To: Gary Goeschel, Wetlands Enforcement Officer  
From: Alex Klose P.E., Town Engineer  
Date: September 8, 2022  
Re: Atlantis Management Group, Proposed Development  
190, 196, 202 Flanders Road  
Application for Inland Wetlands Permit Review

**PROPOSED COMMERCIAL DEVELOPMENT**  
190, 196 & 202 FLANDERS ROAD  
EAST LYME, CONNECTICUT

REVISIONS	Desc.
No.	Date
Designed	X.XX.
Drawn	X.XX.
Reviewed	X.XX.
Scale	1"=30'
Project No.	2101751
Date	07/22/2022
CAD File:	GD210175101
Title	<b>GRADING AND DRAINAGE PLAN</b>
Sheet No.	<b>GD-1</b>

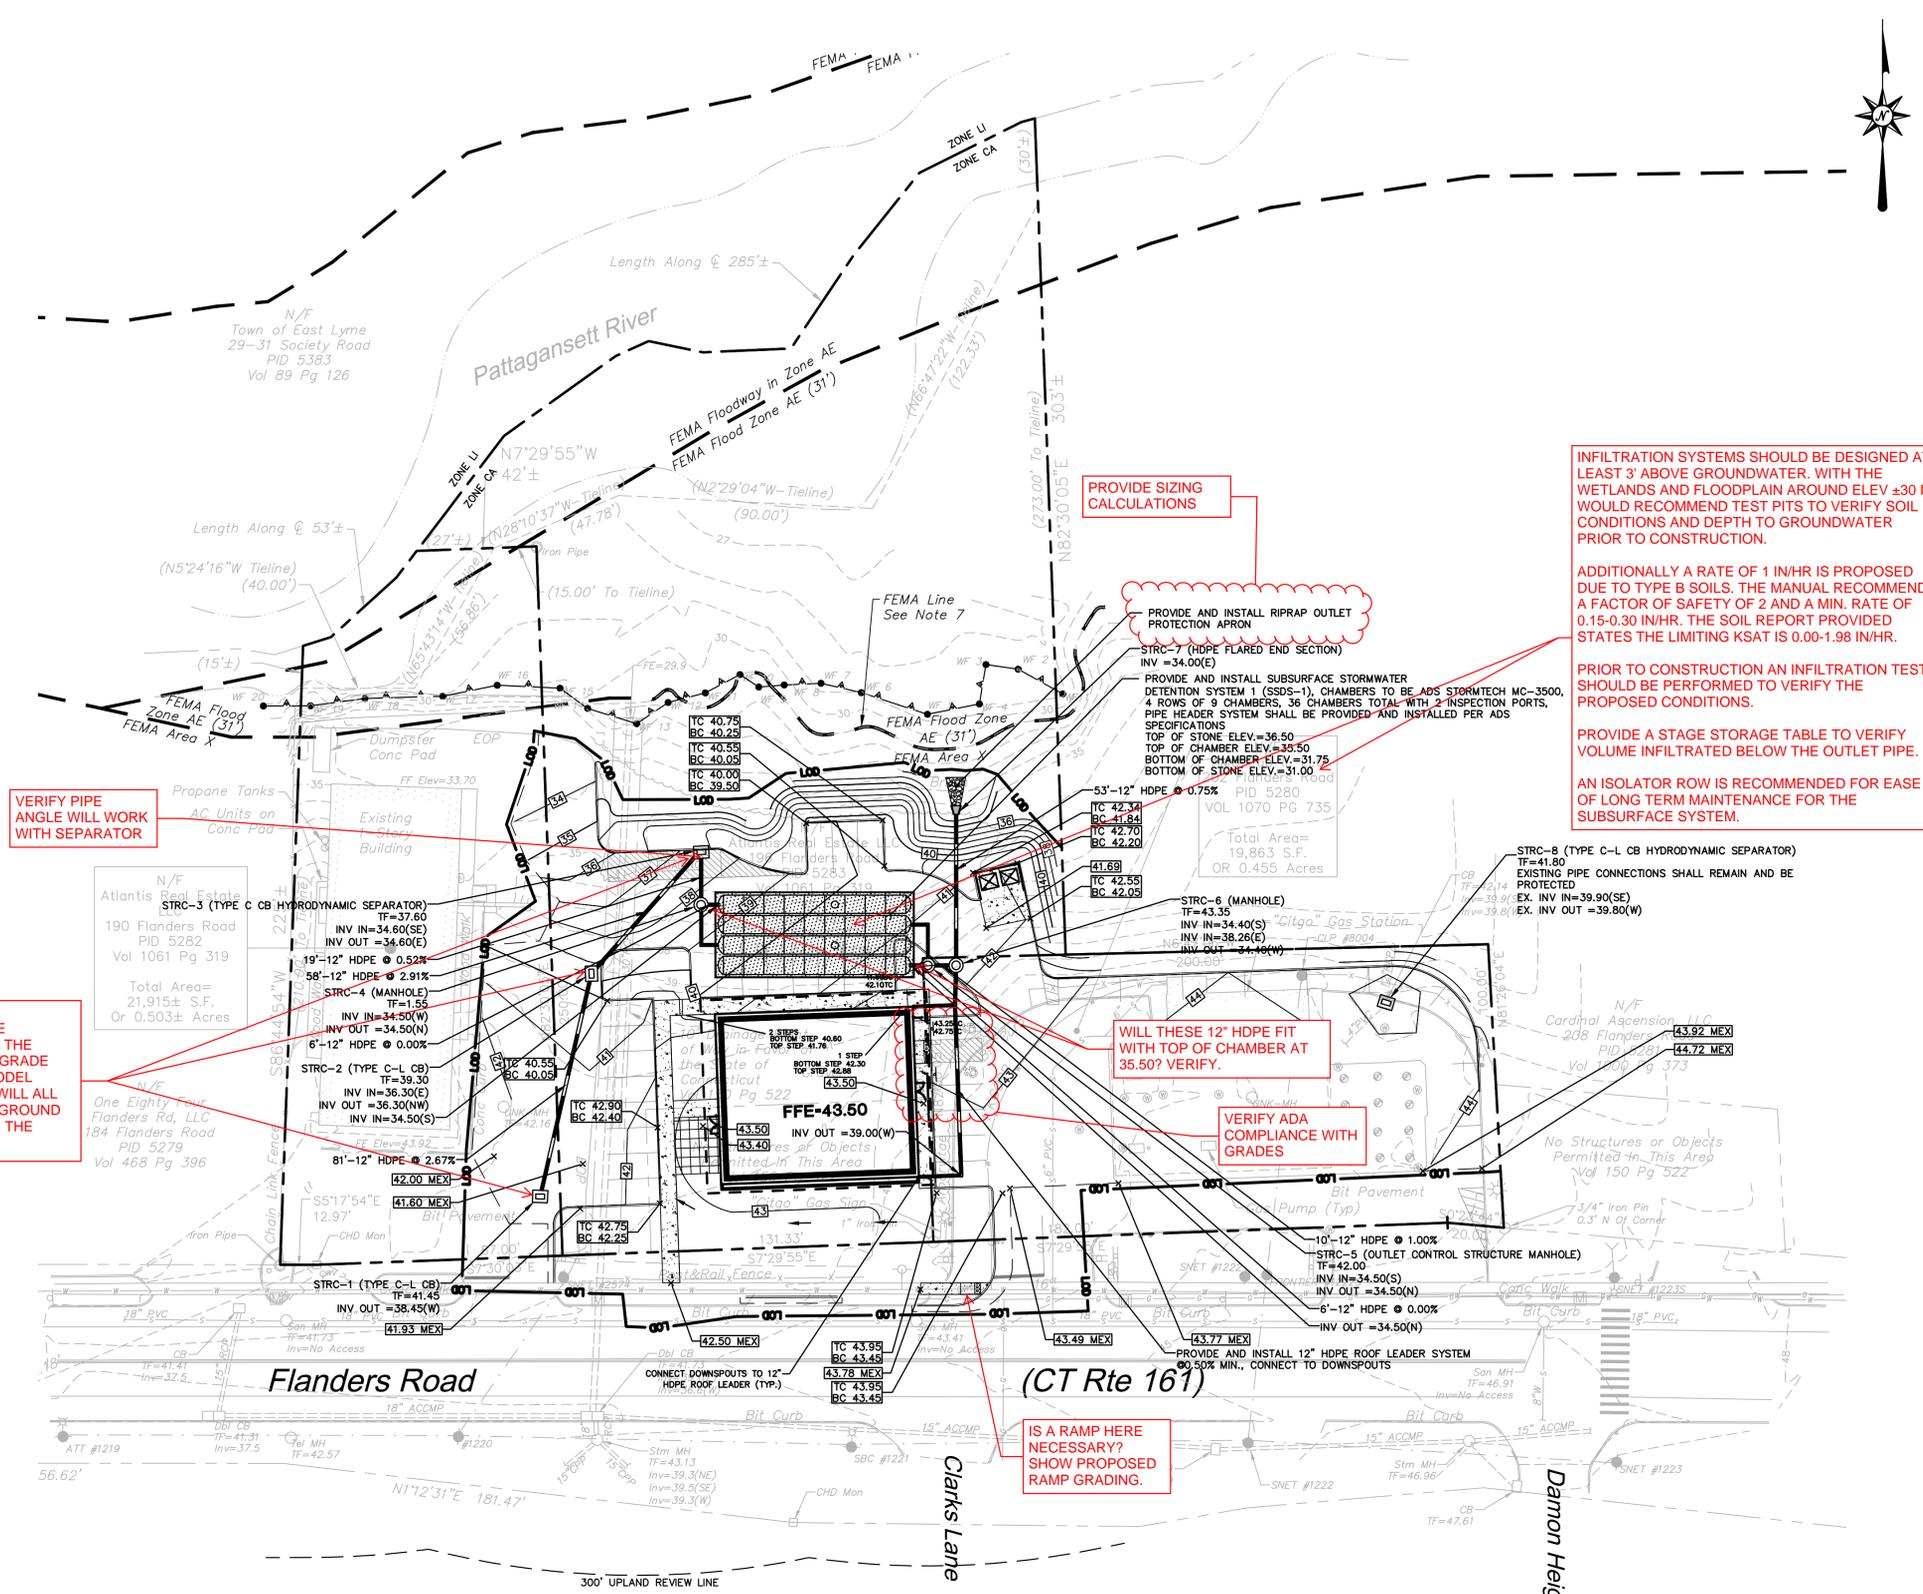
VERIFY PIPE ANGLE WILL WORK WITH SEPARATOR

PROVIDE HYDRAULIC CALCULATIONS FOR THE 100-YEAR STORM SINCE THE CATCH BASINS ARE ON-GRADE AND THE HYDROCAD MODEL ASSUMES THIS WATER WILL ALL MAKE IT TO THE UNDERGROUND SYSTEM TO ATTENUATE THE 100-YEAR STORM.

PROVIDE SIZING CALCULATIONS

PROVIDE AND INSTALL RIPRAP OUTLET PROTECTION APRON

INFILTRATION SYSTEMS SHOULD BE DESIGNED AT LEAST 3' ABOVE GROUNDWATER. WITH THE WETLANDS AND FLOODPLAIN AROUND ELEV ±30 I WOULD RECOMMEND TEST PITS TO VERIFY SOIL CONDITIONS AND DEPTH TO GROUNDWATER PRIOR TO CONSTRUCTION.

ADDITIONALLY A RATE OF 1 IN/HR IS PROPOSED DUE TO TYPE B SOILS. THE MANUAL RECOMMENDS A FACTOR OF SAFETY OF 2 AND A MIN. RATE OF 0.15-0.30 IN/HR. THE SOIL REPORT PROVIDED STATES THE LIMITING KSAT IS 0.00-1.98 IN/HR.

PRIOR TO CONSTRUCTION AN INFILTRATION TEST SHOULD BE PERFORMED TO VERIFY THE PROPOSED CONDITIONS.

PROVIDE A STAGE STORAGE TABLE TO VERIFY VOLUME INFILTRATED BELOW THE OUTLET PIPE.

WILL THESE 12" HDPE FIT WITH TOP OF CHAMBER AT 35.50? VERIFY.

VERIFY ADA COMPLIANCE WITH GRADES

IS A RAMP HERE NECESSARY? SHOW PROPOSED RAMP GRADING.
